Addendum 02

Project: Doon Public School - Window Replacement & HVAC Upgrades
1401 Doon Village Road, Kitchener ON
N2P 1A8, Breslau ON

Date: 13 May 2021

Tender No. 7158-KP-21

1. DRAWING MP-101 – GROUND FLOOR DEMOLITION PLAN - PLUMBING (ISSUED HEREWITH)

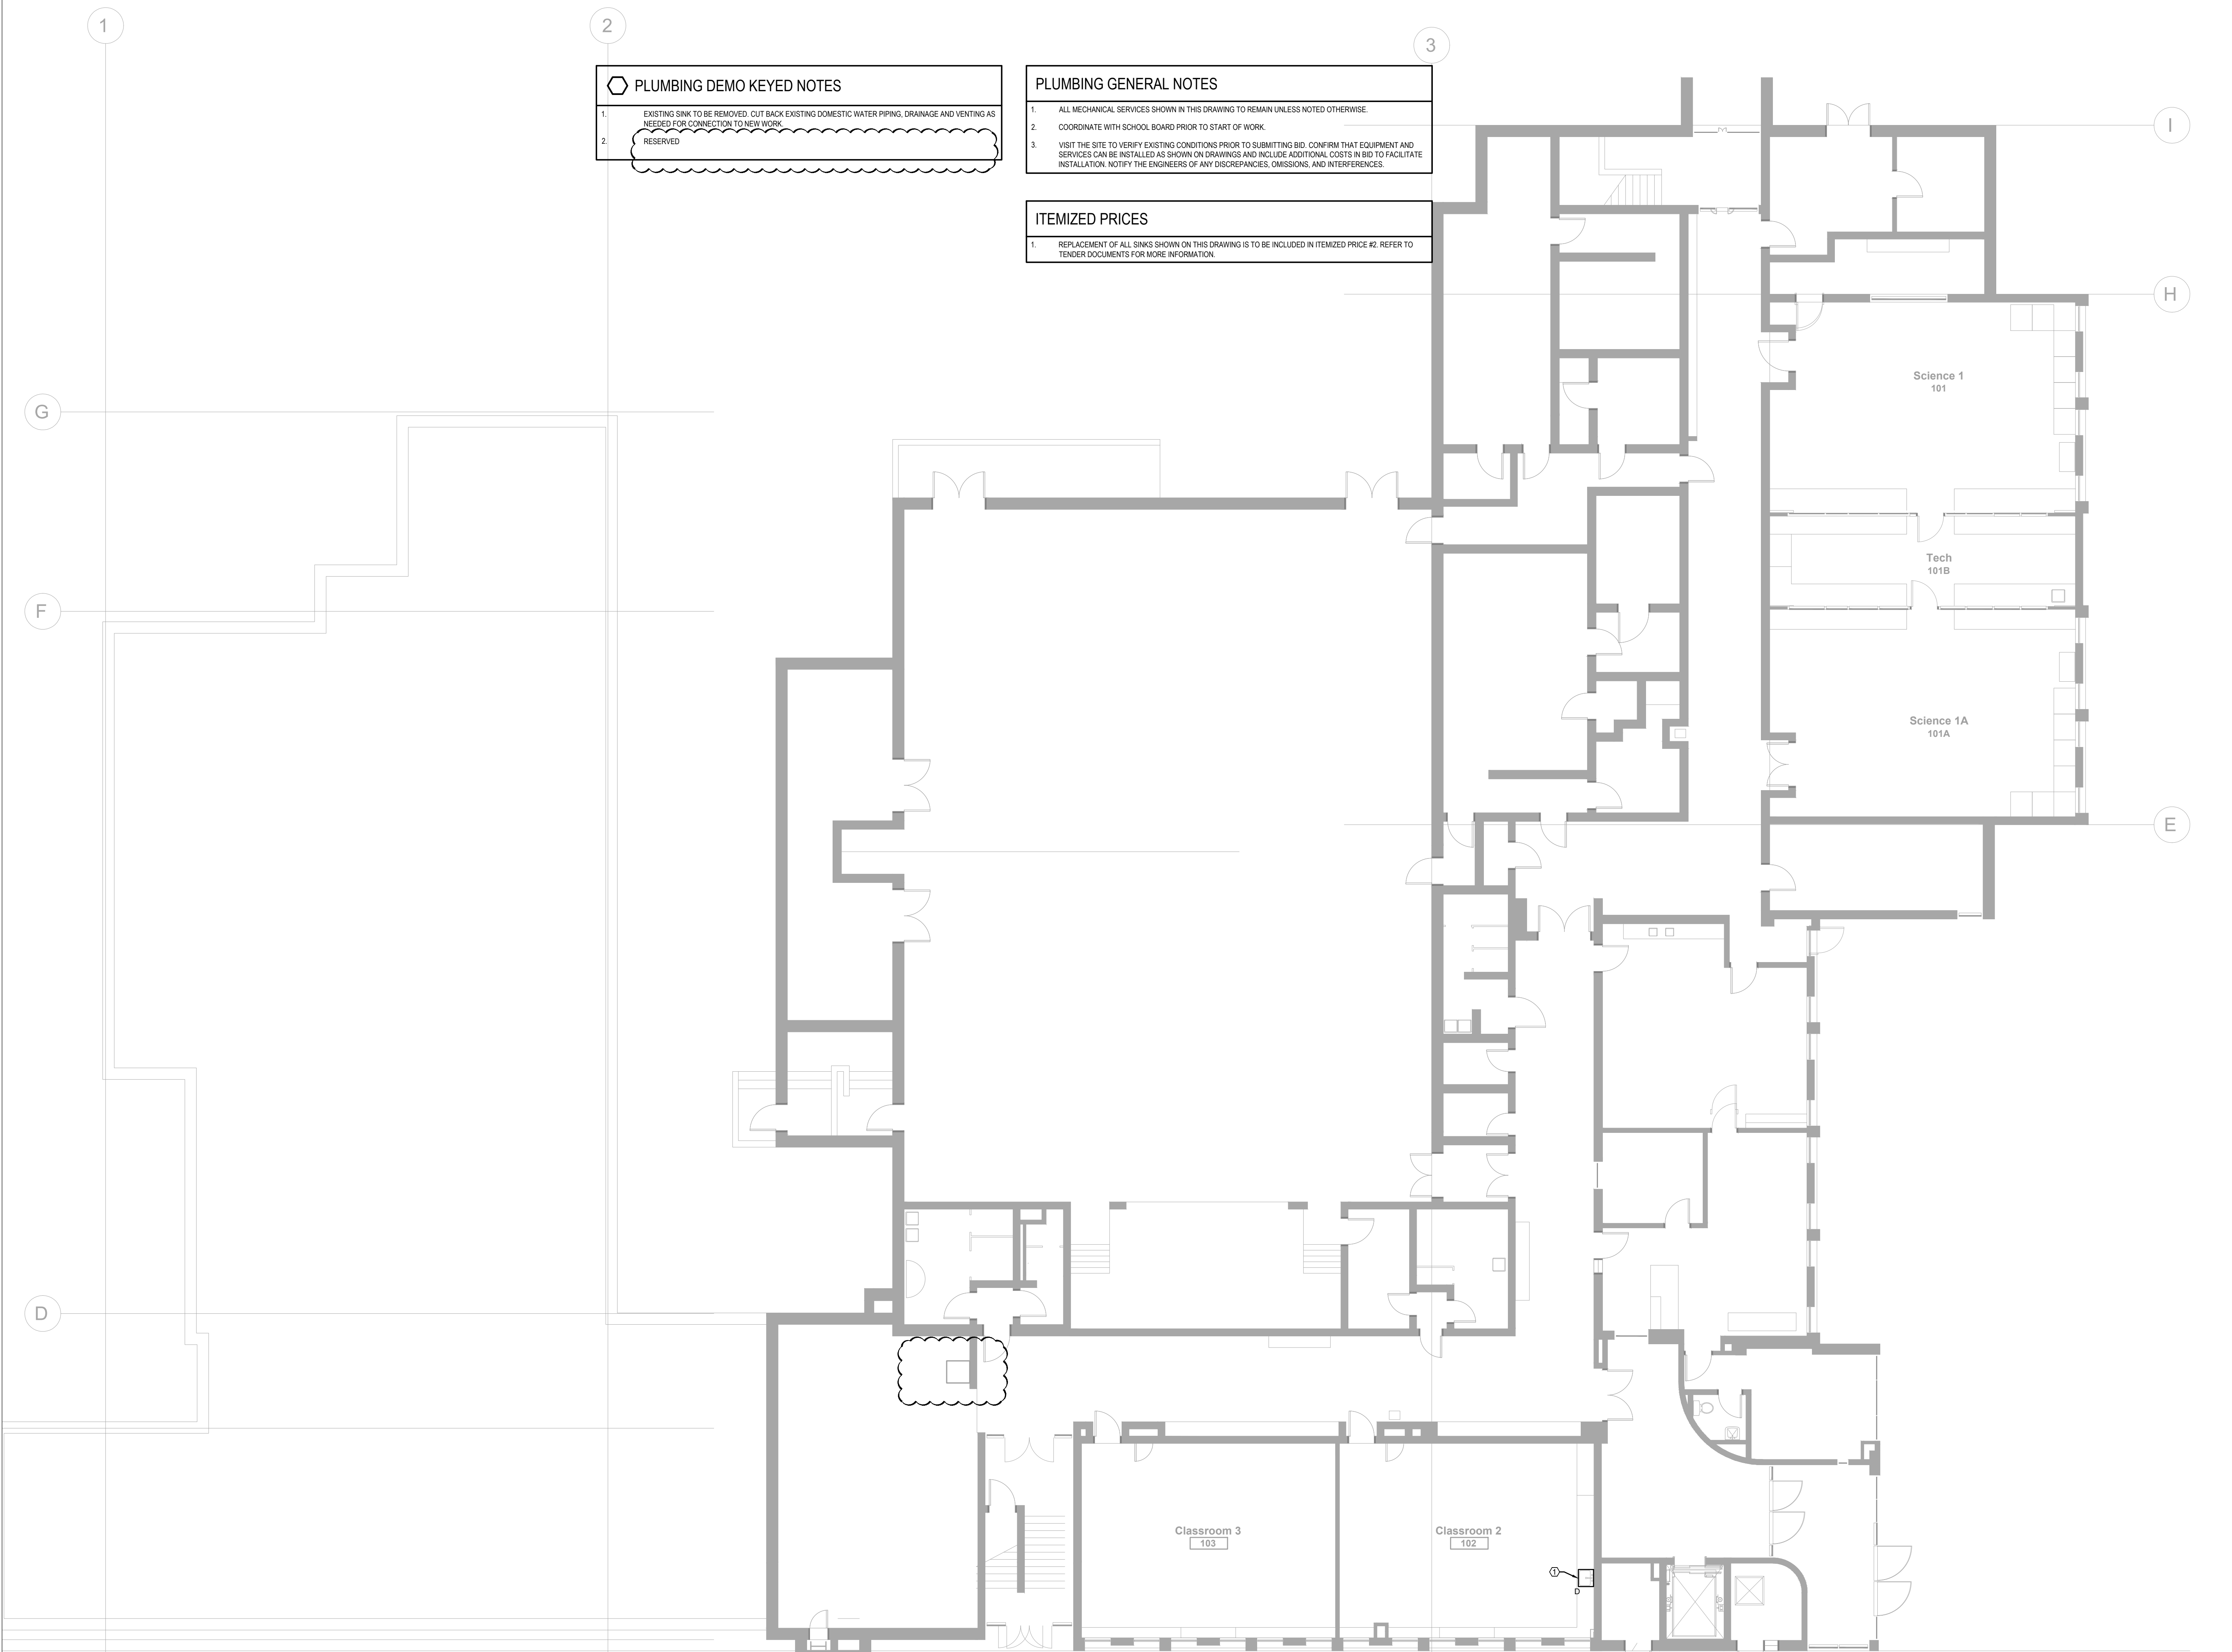
- a. Existing Mop sink in boiler room to remain.
